UNITED STATES PATENT AND TRADEMARK OFFICE

APPLICATION NO.	FILING DATE	FIRST NAMED INVENTOR	ATTORNEY DOCKET NO.	CONFIRMATION NO.
09/936,275	12/21/2001	Paul Schwcizer	115-011459	3957
7590 William H Logsdon 700 Koppers Building 436 Seventh Avenue Pittsburgh, PA 15219-1818		01/17/2007	EXAMINER WELCH, GARY L	
			ART UNIT 3765	PAPER NUMBER
SHORTENED STATUTORY PERIOD OF RESPONSE		MAIL DATE	DELIVERY MODE	
3 MONTHS		01/17/2007	PAPER

Office Action Summary	Application No.	Applicant(s)
	09/936,275	SCHWEIZER, PAUL
	Examiner Gary L. Welch	Art Unit 3765

DETAILED ACTION

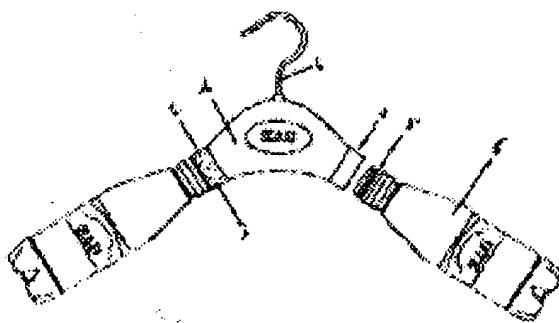
6. Claims 32-41, 43-49 and 51 are rejected under 35 U.S.C. 102(a) as being anticipated by Pelliger (FR 002779630 A1).

Pelliger discloses a hook 4 for a hanger having a fastening part including a pair of recesses 2 positioned therein. At least one of the pair of recesses 2 includes threads configured to receive corresponding threads 3 on a beverage bottle container 6. The hook 4 extends along a vertical axis thereby defining a horizontal axis disposed at a 90-degree angle therefrom. The recesses 2 extend at an angle divergent from the horizontal axis.
